19 December 2019

## RE SUBMISSION TO SYDNEY GATEWAY ROAD PROJECT SSI-9737

This submission has been prepared on behalf of Qantas Airways Limited including related bodies corporate of Qantas (**Qantas**) in relation to the State Significant Infrastructure Application (**SSIA**) and preliminary draft Major Development Plan (**MDP**) for the Sydney Gateway Road Project (**Gateway Project**) submitted by Roads and Maritime Services (**RMS**) now known as Transport for NSW (**TfNSW**) and Sydney Airport Corporation Limited (**SACL**).

Figure 2 - Construction Vibration Assessment

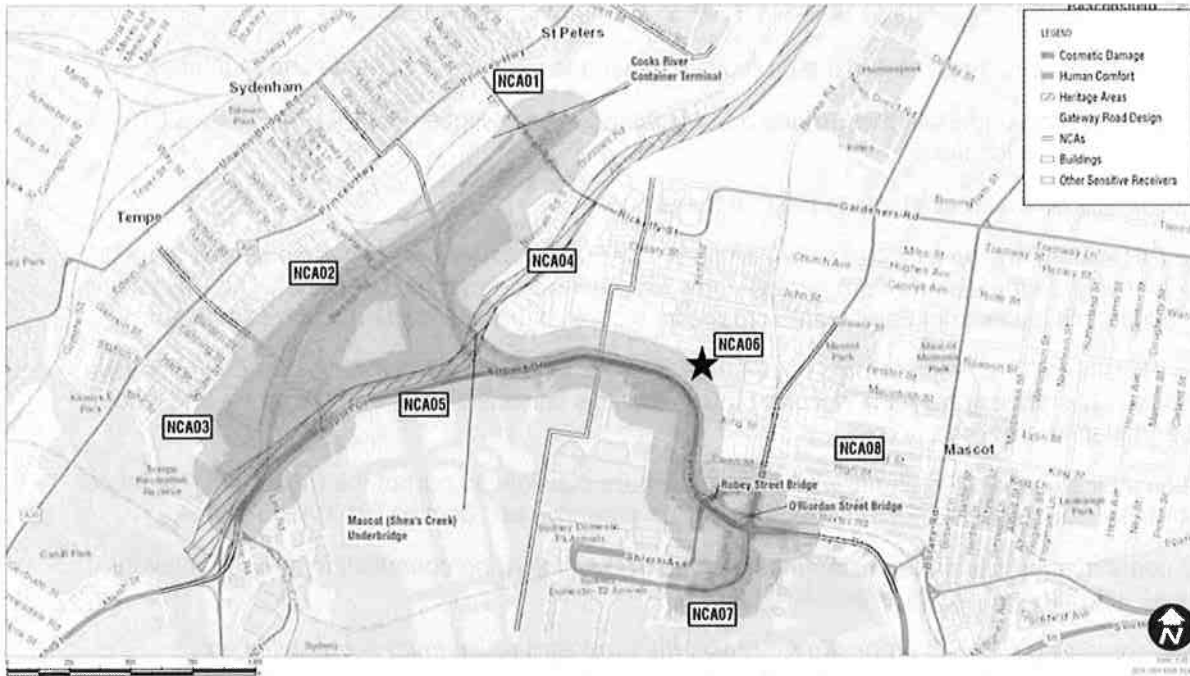
**Figure 2** indicates that some buildings and structures, including the Catering Building (refer red star) are within the recommended minimum working distances for cosmetic damage and human comfort. This includes but is not limited to) the following Qantas buildings on freehold land: Catering Building, Catering Bridge, Joy Building, Leo Building, Archive Building and Engine Test Cell; and the following buildings on the Jetbase: Security Building, Building 147, Fifth Street Car Park, Domestic Freight Terminal, and various aircraft Hangars . In addition, Section 5.10.1 of TWP 2 – Noise and Vibration states:

As highlighted in Figure 2 and stated in Section 5.10.2 of TWP 2 – Noise and Vibration:

*"Certain receivers in the study area are within the human comfort minimum working distance ... occupants of affected buildings may be able to perceive vibration impacts at times when vibration intensive equipment is in use. Where impacts are perceptible, they would likely only be apparent for relatively short durations when equipment such as rockbreakers or vibratory rollers are nearby."*

It is not clear from this limited discussion what the true impact to Qantas' staff, particularly at the Jetbase and Mascot Campus, will be from the use of vibration intensive equipment.

Further investigation on this issue is required together with mitigation measures.

In light of the above, Qantas requests a condition of consent requiring SACL/TfNSW to undertake a dilapidation survey for all of Qantas buildings to ensure that any damage caused by construction works are repaired at the cost of the Gateway Project.
